### **Plan Change 60 - Maxwell Hills Zone – Reply to Request for Further Information**

**RESPONSE TO REQUEST FOR  
FURTHER INFORMATION  
RESOURCE CONSENT  
APPLICATION  
PLAN CHANGE 60 - MAXWELL  
HILLS ZONE**

The following responses, prepared by Riley Consultants Ltd (RILEY), relate to questions raised by Mr Paul Whyte of Beca Carter Hollings & Ferner Ltd (Beca) on behalf of the Marlborough District Council (MDC), in their letter dated 10 June 2011, requesting further information.

TITLE  
**KAPITI VIEWS LTD.**  
**RURAL RESIDENTIAL DEVELOPMENT - PRIVATE PLAN CHANGE**  
**STORMWATER NETWORK PLAN - SHEET 1**

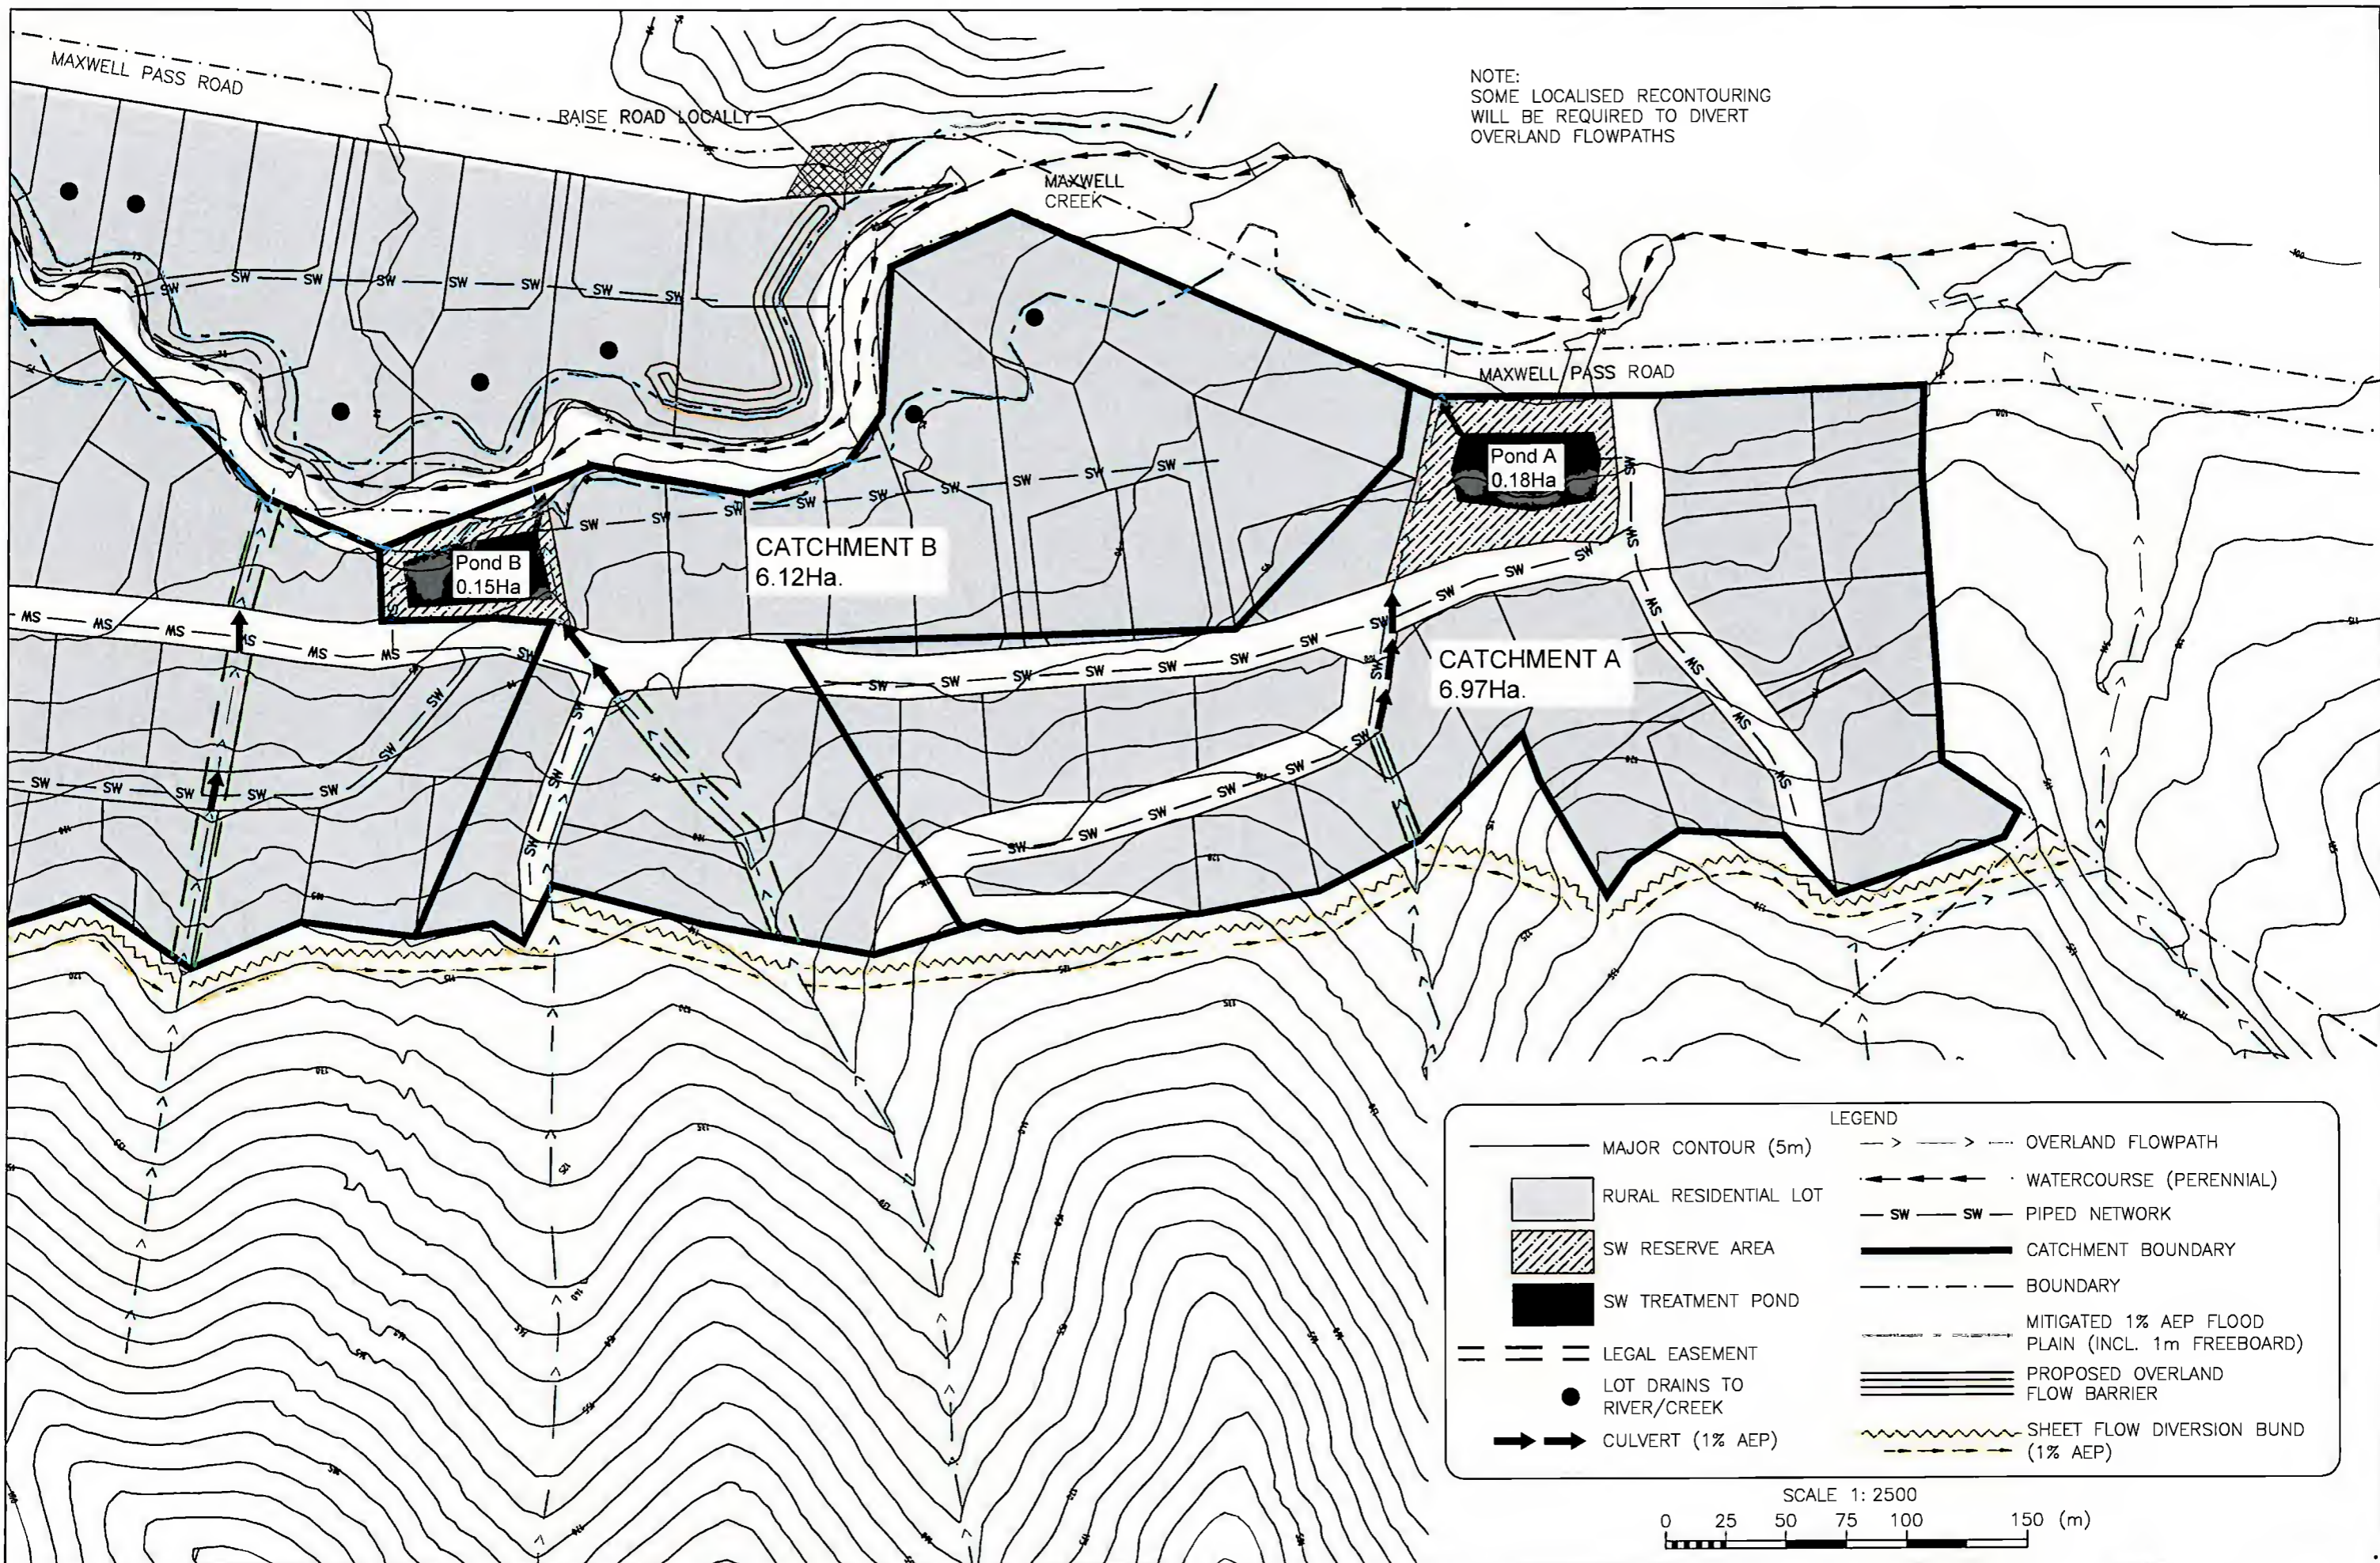
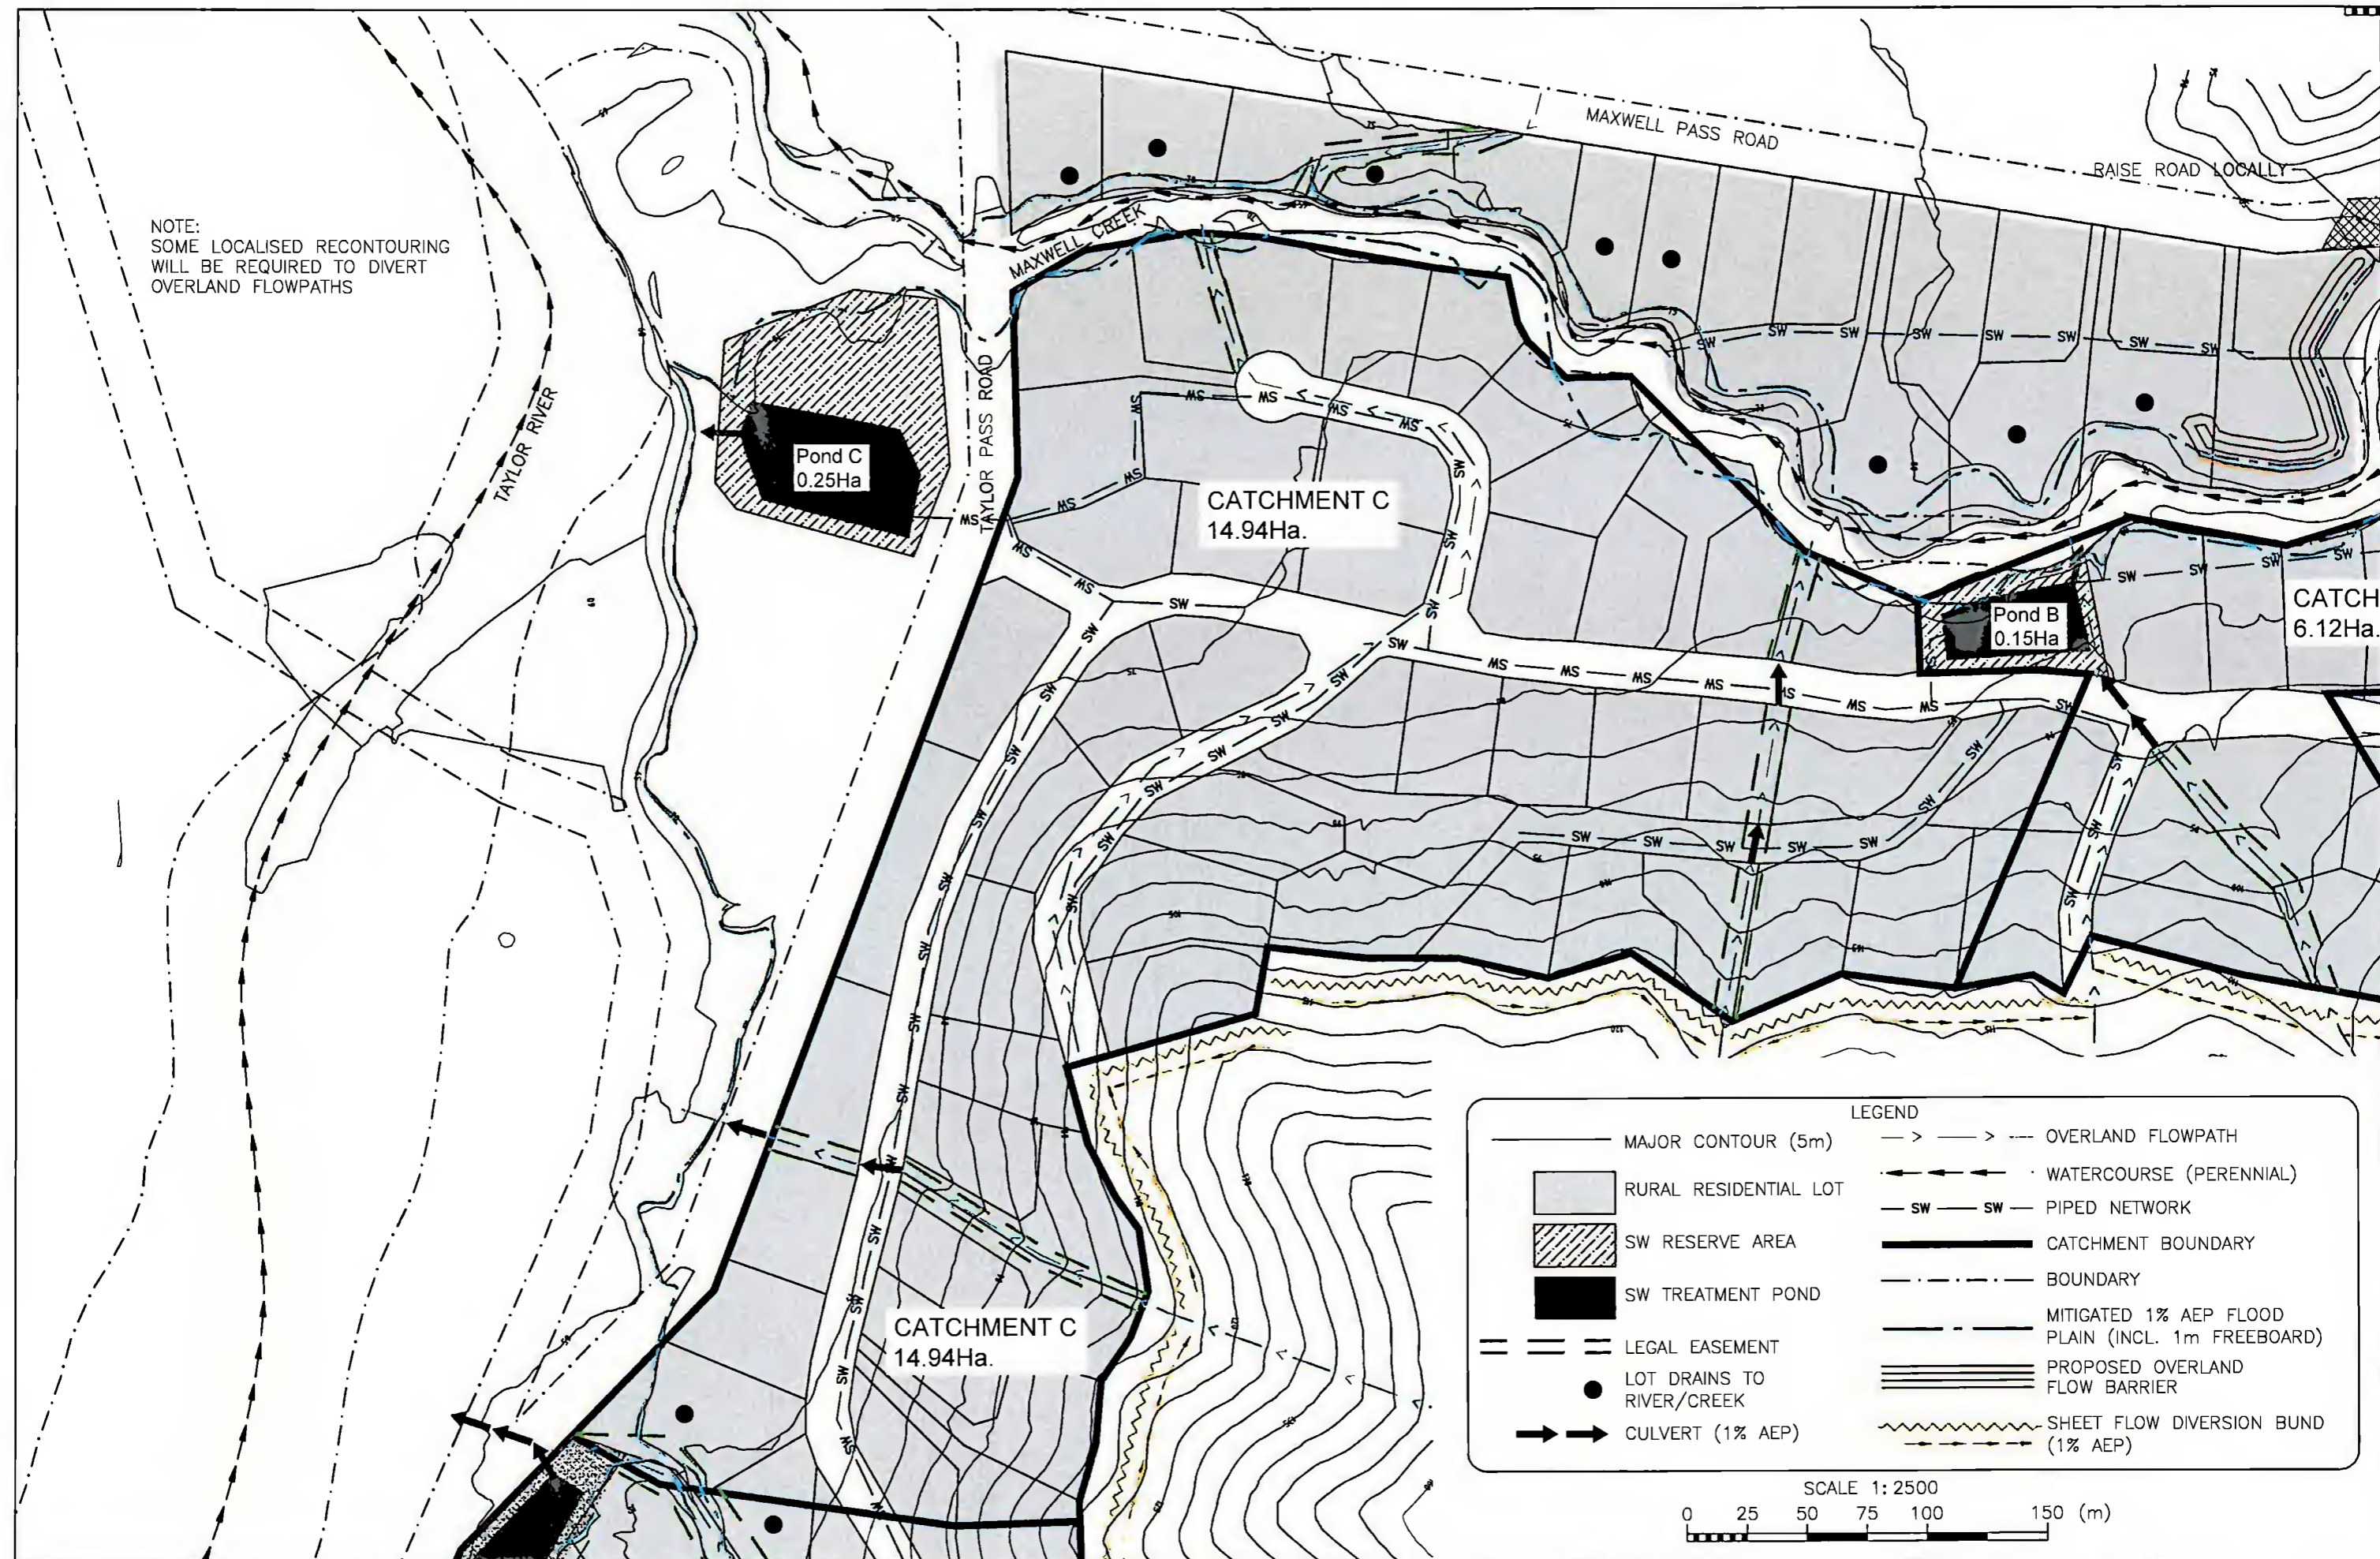
### **Reply to Additional Comments from Mr Brin Williman**

Provision for runoff from the catchment above the plan change area, should be made to allow existing overland flow to continue through the developed area as shown on RILEY Dwgs: 04819/6SW-1 to 4. A number of overland flowpaths have been identified with water passing along roads or easements created along residential boundaries. All stormwater runoff from the catchment above the proposed plan change area will bypass the piped network and treatment ponds. Stormwater from the upper catchment will cross the road network either through a culvert for up to the 1% AEP event or as overland flow via localised depressions in the road network. Overland flow from the upper catchment will ultimately discharge directly to the Maxwell Creek or Taylor River.

As shown on the RILEY Dwgs: 04819/6SW-1 to 4, five water quality ponds (labelled A to E) have been included in the stormwater network. The ponds have been designed in accordance with Auckland Regional Council Technical Publication No.10, 'Stormwater Treatment Devices Design Guidelines Manual', Second Edition, May 2003 (TP10), as prescribed in the MDC Code of Practice. The preliminary pond sizing has been calculated based on the preliminary development scenario for the proposed plan change area as shown on RILEY Dwgs: 04819/6SW-1 to 4. The pond sizing includes for impervious areas (i.e. roads, roof, and private hardstand areas) and are summarised below in Table 2.
